SITE PLAN REVIEW AND APPEARANCE BOARD STAFF REPORT

Fifth Avenue Townhomes

Meeting	File No.	Application Type
October 23, 2024	2024-056-SPR-LV2	Level 2 Site Plan with
Property Owner		Authorized Agent
Fifth Avenue Delray, LLC		Thomas F. Carney, Jr. of Carney Stanton P.L.

Consideration of a Level 2 Site Plan to construct a five-unit townhouse development with detached garages, Architectural Elevations, and Landscape Plan with a landscape waiver and an internal adjustment to the side interior setbacks for swimming pools.

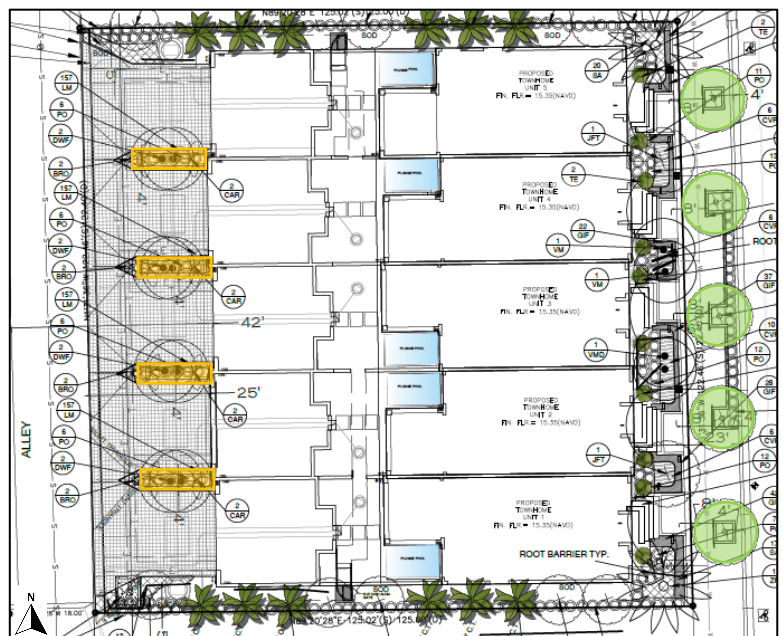
Each of the five proposed townhomes includes a swimming pool amenity between the unit and the detached garage. **LDR Section 4.6.15(G)(3)** requires a minimum five-foot side interior setback for swimming pools in townhouse developments. While the swimming pools for unit 1 and unit 5 comply with the minimum required side interior setbacks, the swimming pools for unit 2, unit 3, and unit 4 encroach into the side interior setbacks. The applicant is requesting an Internal Adjustment to allow a reduced side interior swimming pool setback of four inches in lieu of the required five feet for the swimming pools on unit 2, unit 3, and unit 4 (pictured at left).

Generally, the intent of the five-foot interior pool setback is based on safety precautions to ensure there is a clear and accessible means of ingress/egress from the pool area on all sides in the event an emergency were to occur. The swimming pools on unit 2, unit 3, and unit 4 have over five feet of clearance on two of the four sides. The applicant asserts that the narrow lot dimensions greatly constrain the feasible locations for the swimming pools. As currently configured, if

Technical Notes

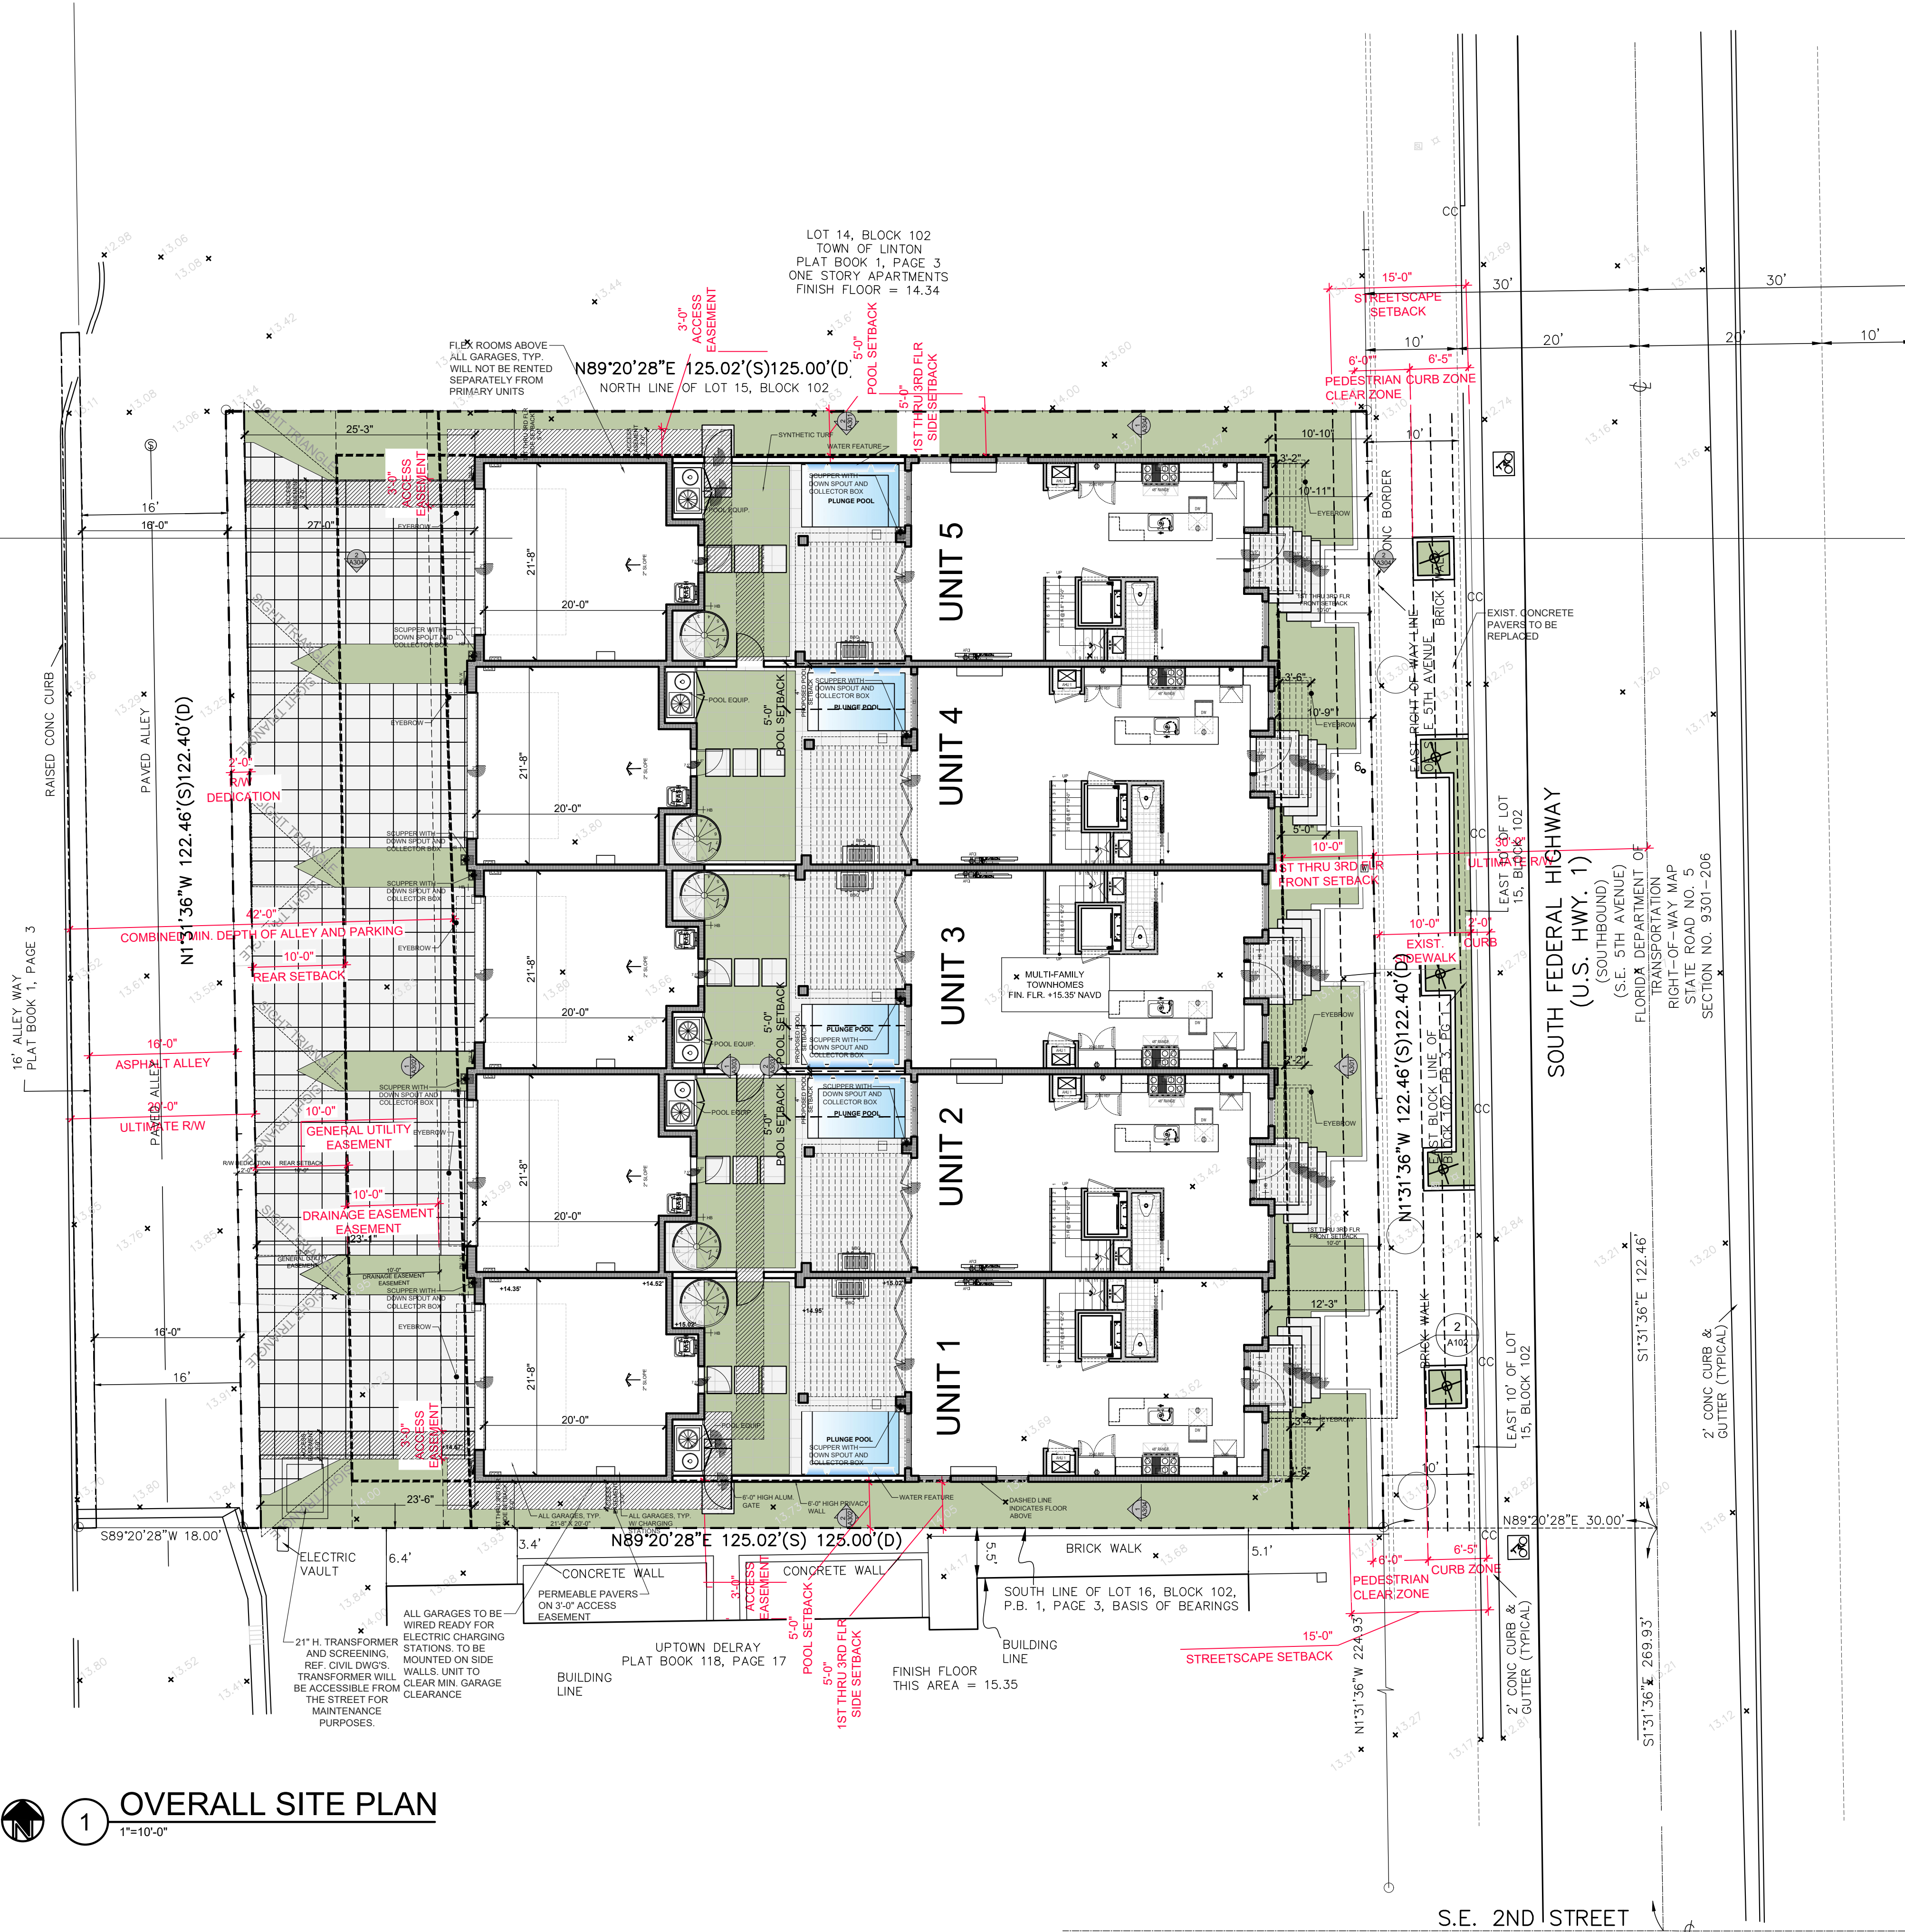
1. Complete a sidewalk easement agreement, in a form acceptable to the City Attorney, for the portion of the pedestrian clear zone located within the front setback.

4. Provide the specifications and square footage for the proposed artificial turf between the primary dwelling unit and the detached garage to ensure compliance with LDR Section 4.6.16(E)(12), Artificial Turf.

1. Show and label all existing underground utilities pipelines and components on the water and sewer plan sheets even if they are shown and labeled on the demo plan. Existing items such as WM, SS gravity mains, RC WM, Raw WM, service lines, laterals, MHs, meters, cleanouts. Also, make sure to label them accordingly indication size, pipe materials (PVC, DI, VCP, etc.) and type (WM, RC, etc.). Indicate what will be proposed to all existing items.

2. Show existing meters sizes, account number, and serial number on the water and sewer plan sheets. Indicate what will be proposed to all existing items.

3. Demonstrate that irrigation plans are consistent with the water and sewer plans in terms of meter and water source for irrigation sprinkler system.
4. Demo does not show existing sewer connections and if they are to remain/ be removed. Clearly label the water meter, RP and PVB at the solenoid valve, with size and type.
